Upper Trinity River Central City Fort Worth, Texas

Final Supplement No. 1
to the Final
Environmental Impact
Statement

Prepared by:
U.S. Army Corps of Engineers
Fort Worth District

March 2008

Figure 9 - Identified Valley Storage Sites to Meet Minimum Requirement

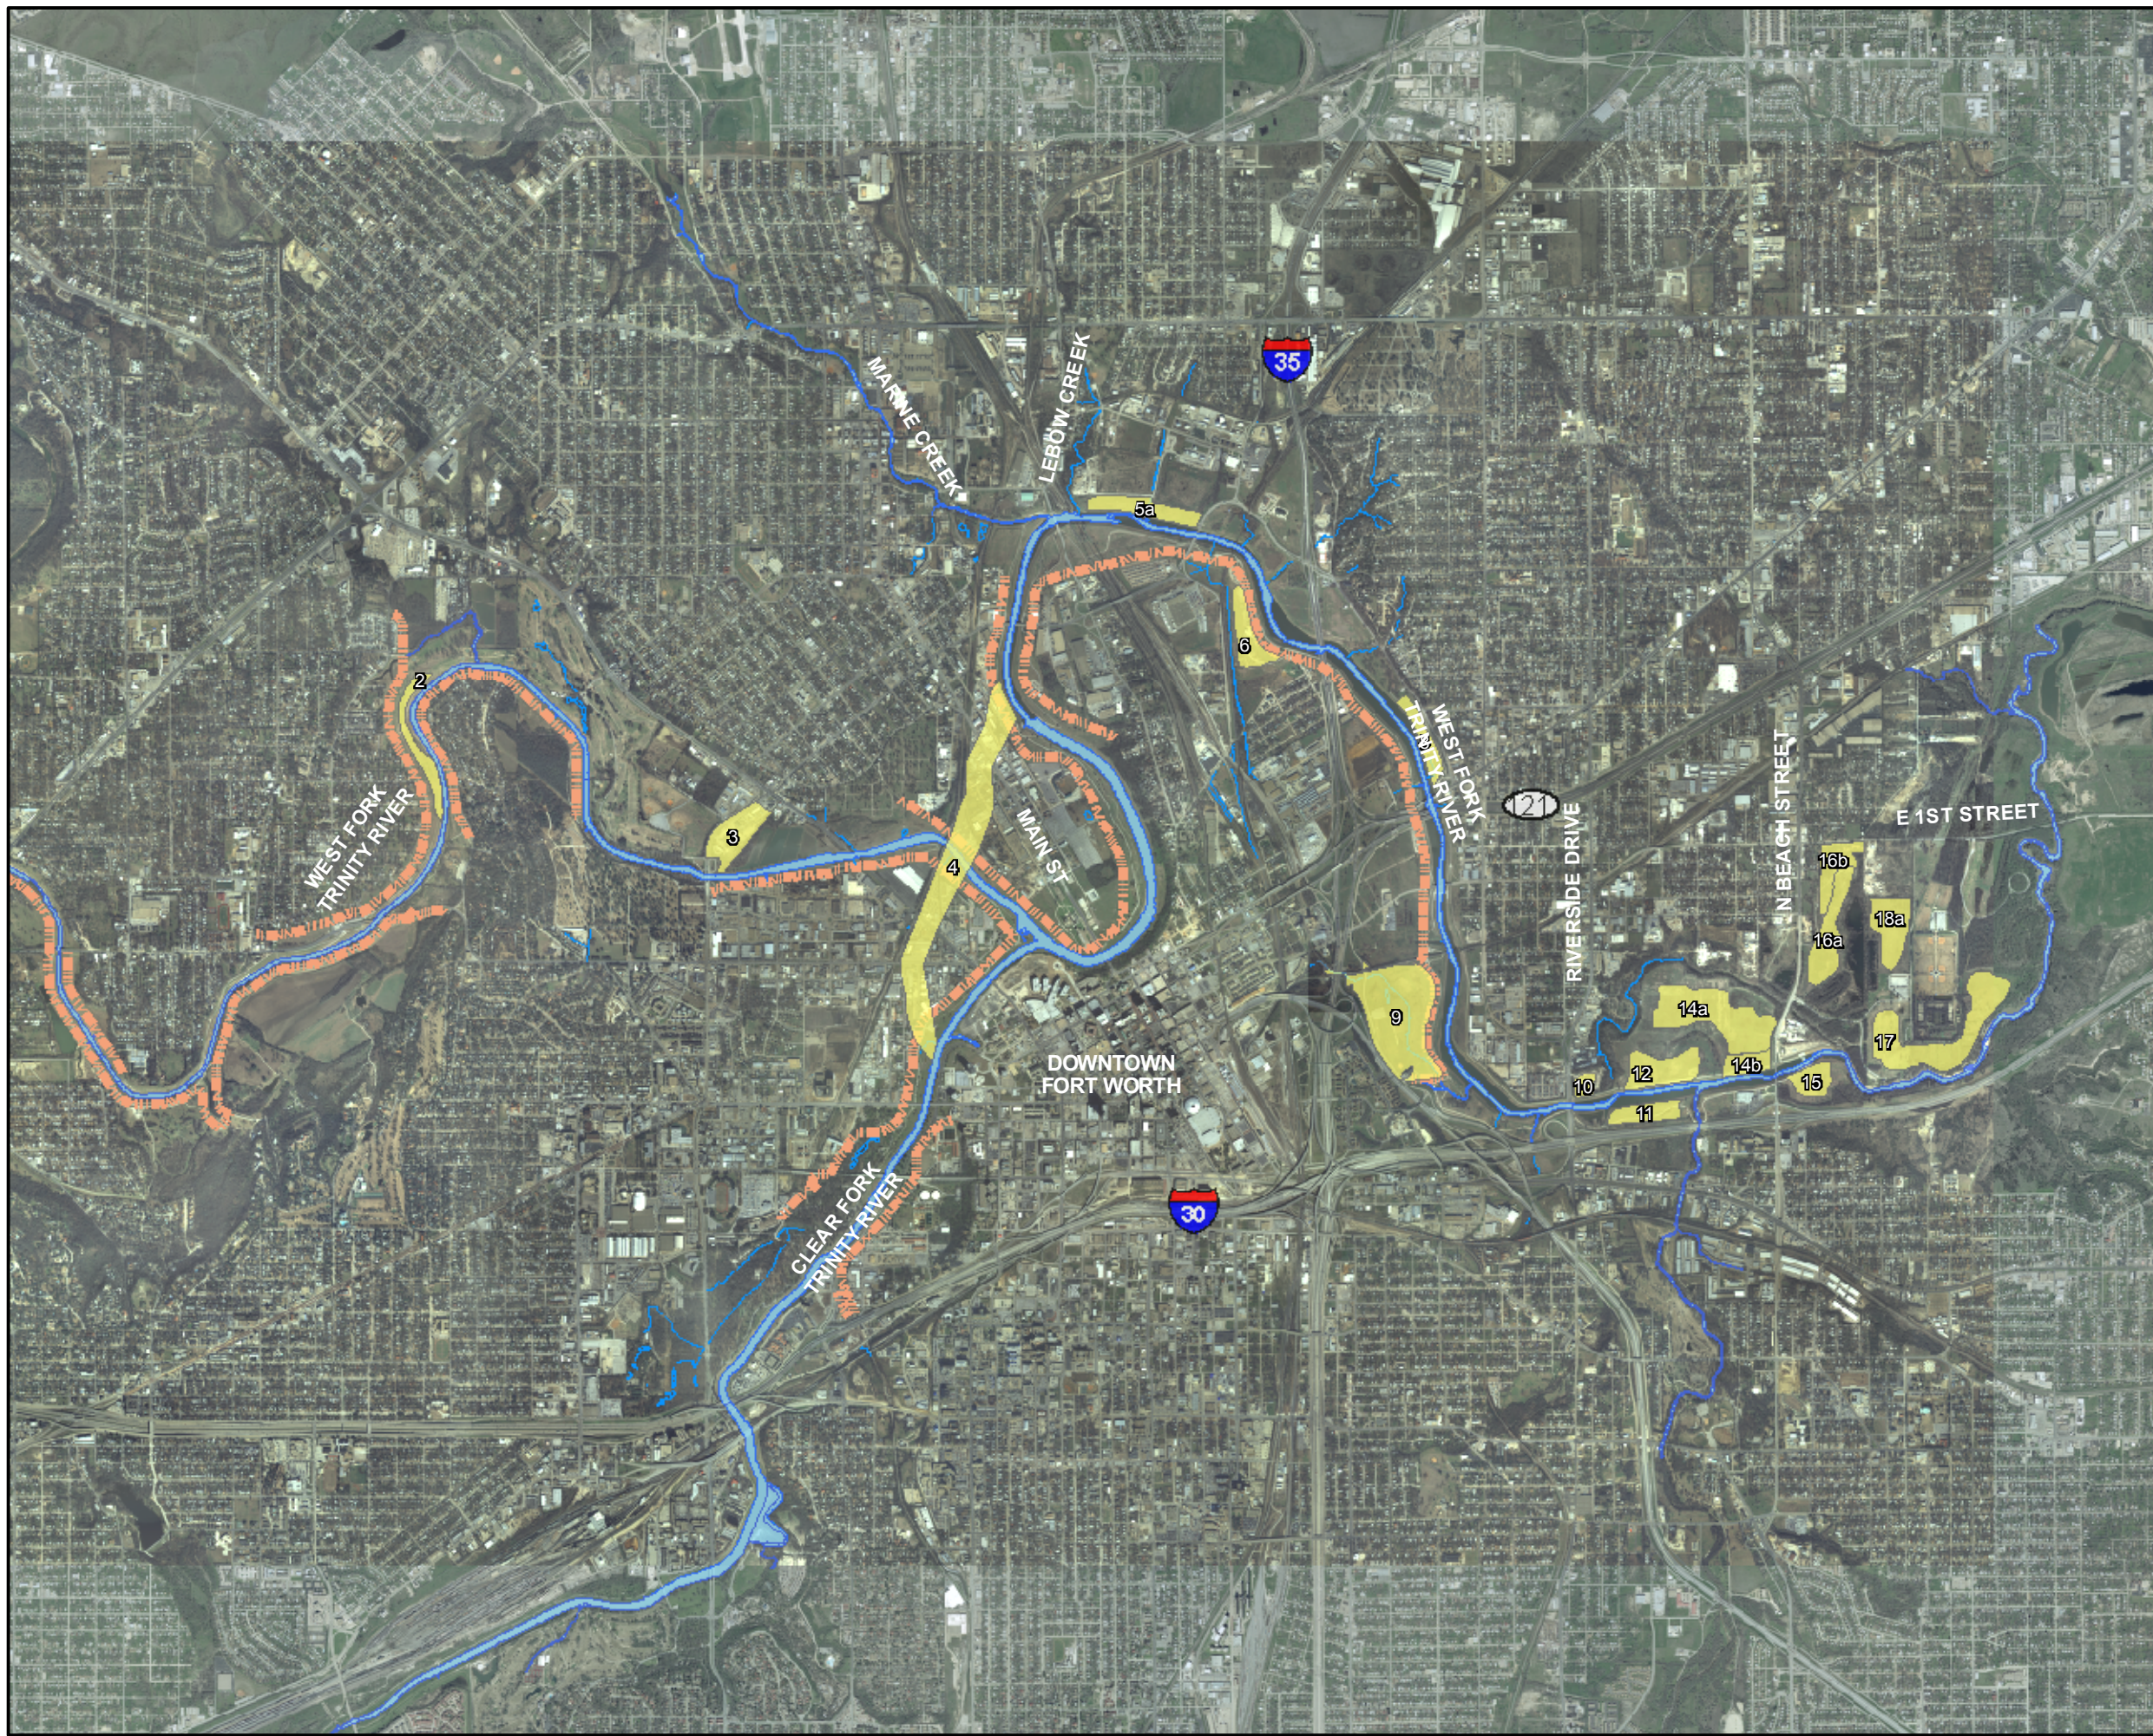
Included in the sites owned by Bowen Properties are a number of tracts of vacant land east of Downtown Fort Worth. In particular Bowen Properties is the owner of sites numbered 10, 16a, 16b and 18b in Figure 9 of the DSEIS.

Figure 10 - Modified Central City Recommended Valley Storage Plan

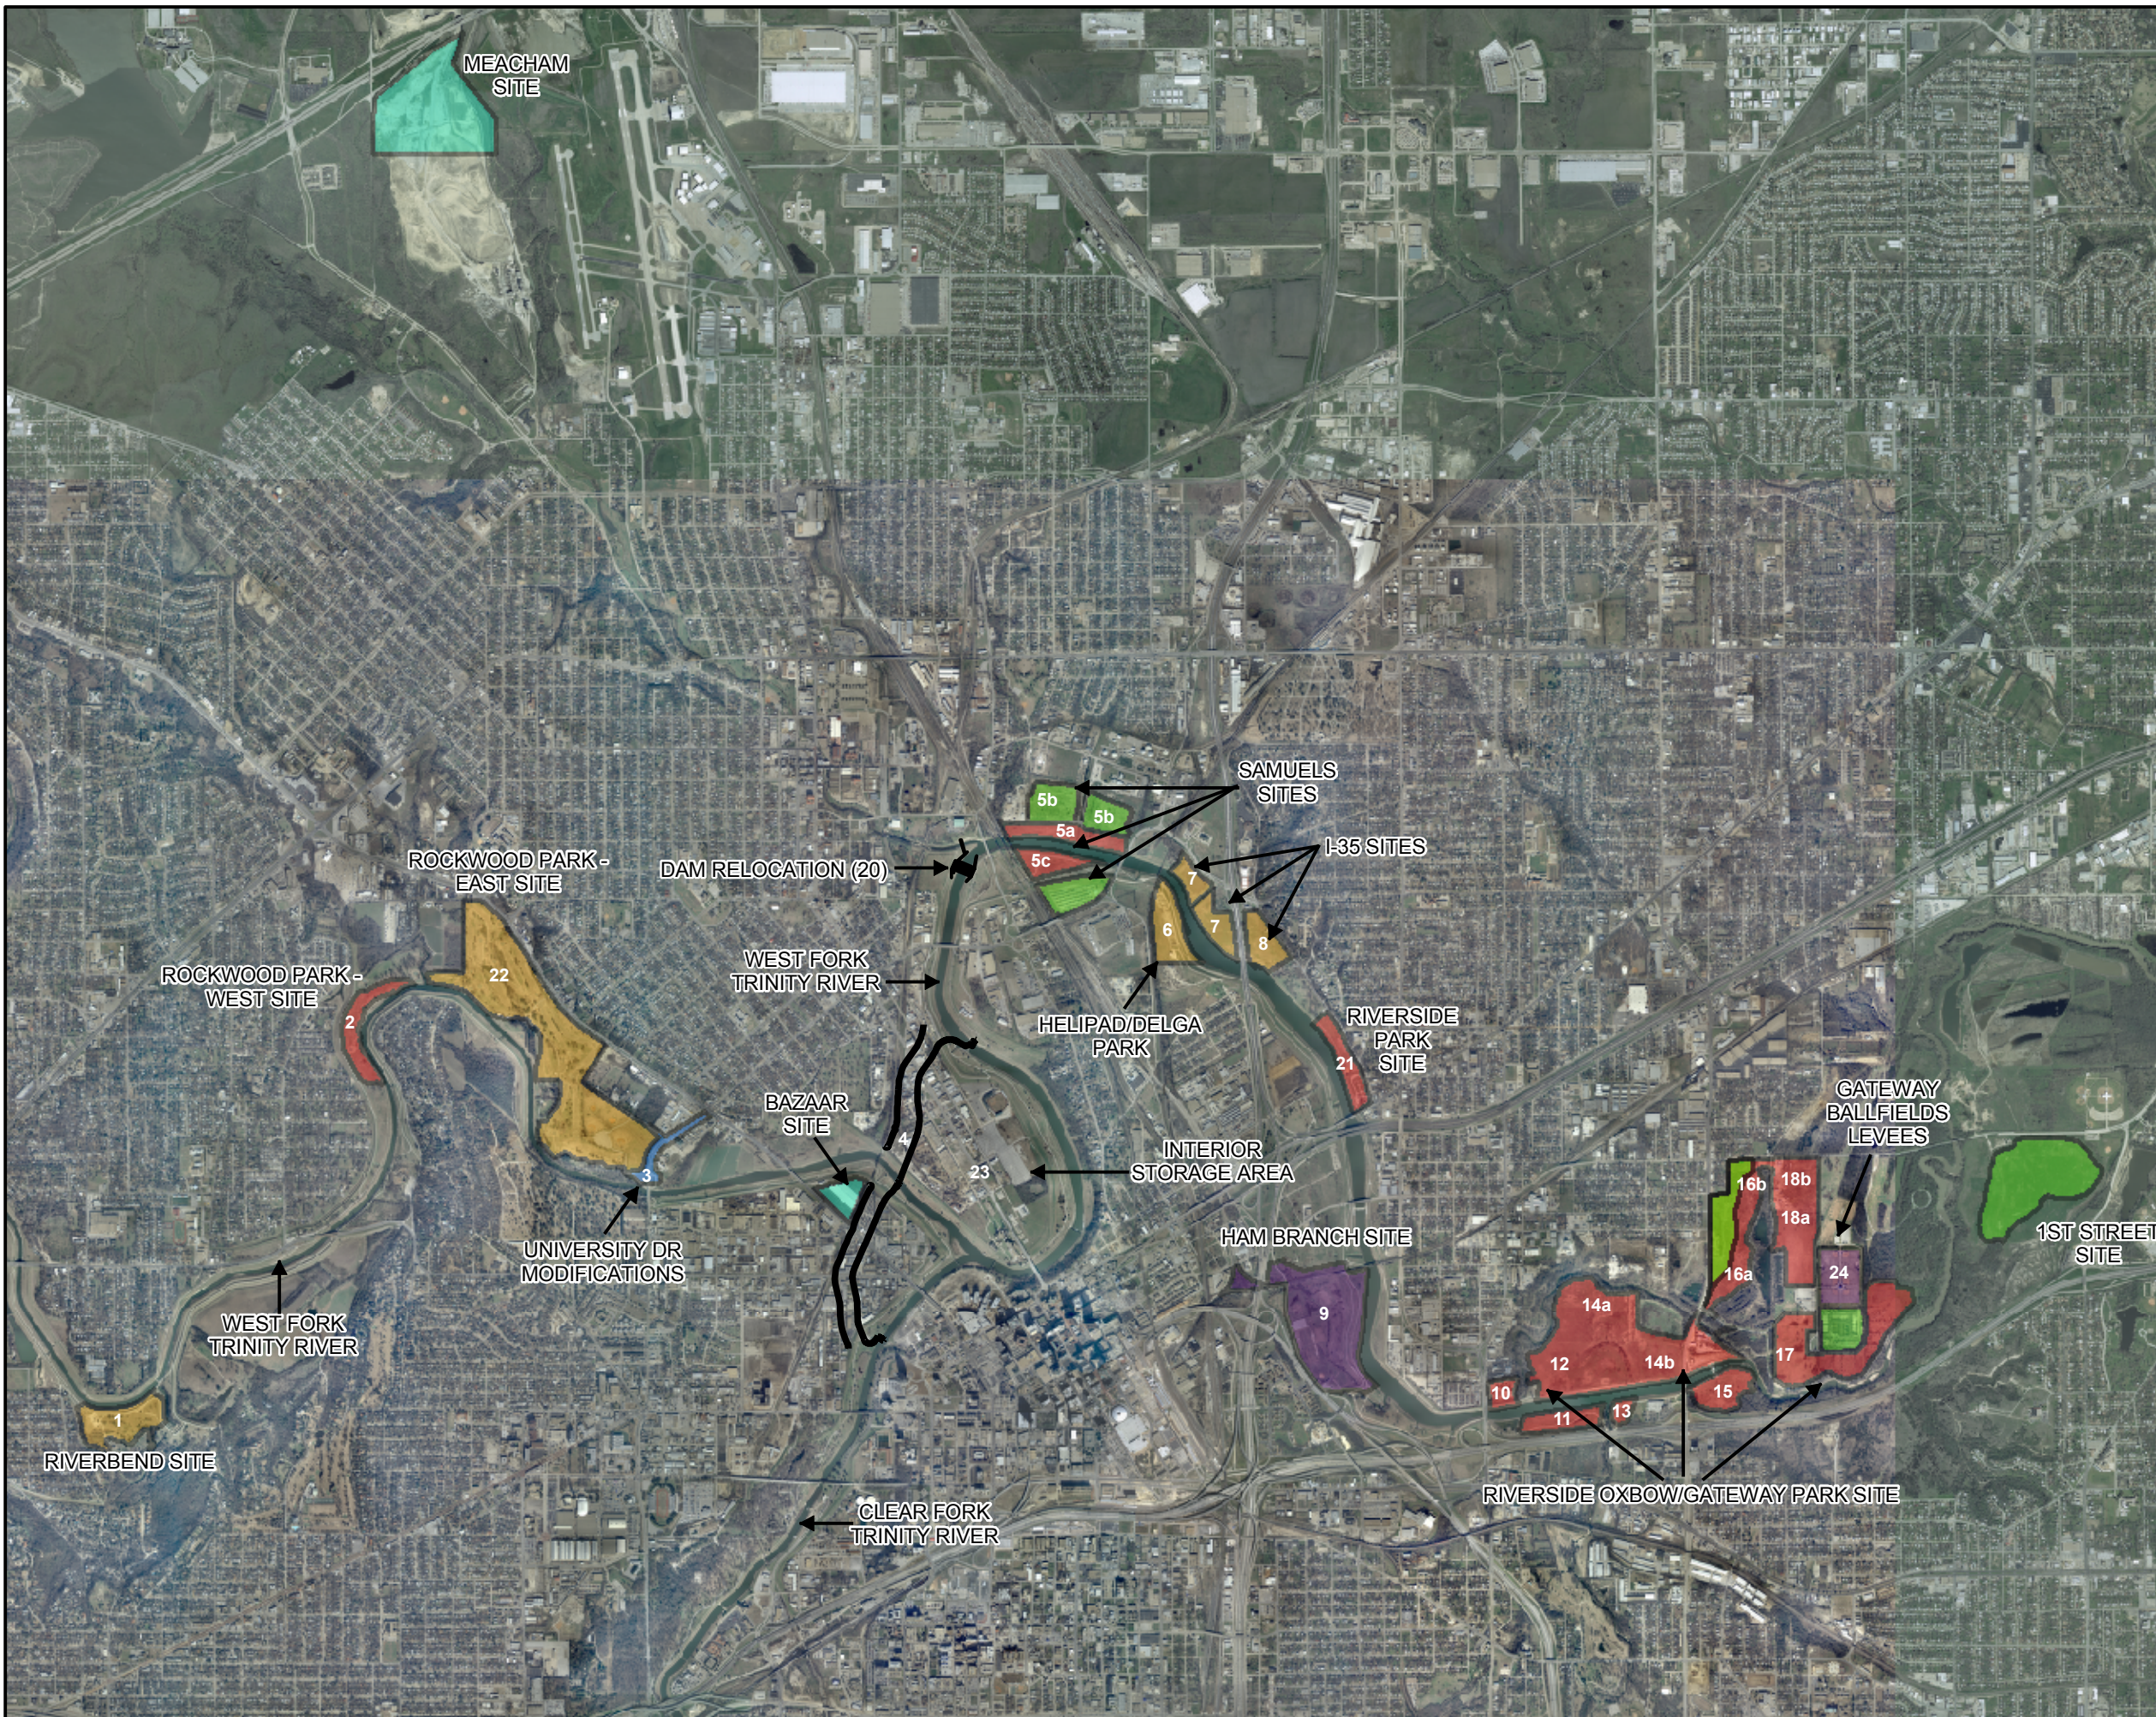
Figure 7 shows Essential Restoration Lands bounded along the old river oxbow and Figures 8 and 9 indicate potential valley storage sites, specifically Site ID 10 and 14a, within the Riverside Oxbow area that would avoid the Essential Restoration Lands. Figure 10, on the other hand, indicates Recommended Valley

Storage – Cut locations for Site ID 10 and 14a that are not of similar size as those identified in Figures 8 and 9 and thus encroach on the Essential Restoration Lands. The Central City Habitat Development Plan for the Riverside Oxbow Area, Figure 12, shows a reduced amount of restored buffer along the Oxbow than was originally proposed in the Approved Riverside Oxbow Ecosystem Restoration Project, Figure 2. The new plan has “turf grass” planting proposed in the Essential Restoration Land area along oxbow.

The portion of overall Site 8 (figure 10) that would be used as a contingency site is on private lands adjacent to IH-35. It was formerly used as a farmland and has mixed vegetation regrowth, mostly formland and early successional grassland and shrubs. Moving site 8 further south would put it into the forested area or into a primary valley storage site (Site 21). Site 21 avoids impacts to the stream and forested areas of Riverside Park.

The original Riverside Oxbow project report findings were utilized along with recent field investigations and review of existing imagery to determine environmentally sensitive areas for establishing boundaries on Figure 7 to promote a planning objective of minimizing impacts to existing high quality resources and those high quality resources that would have been established should Riverside Oxbow Restoration Project be authorized for construction (essential restoration lands). As you have noted all impacts could not be avoided, however through planning discussions between hydraulic, civil and environmental planners, the impacts were minimized to the extent possible within the accuracy of information available.
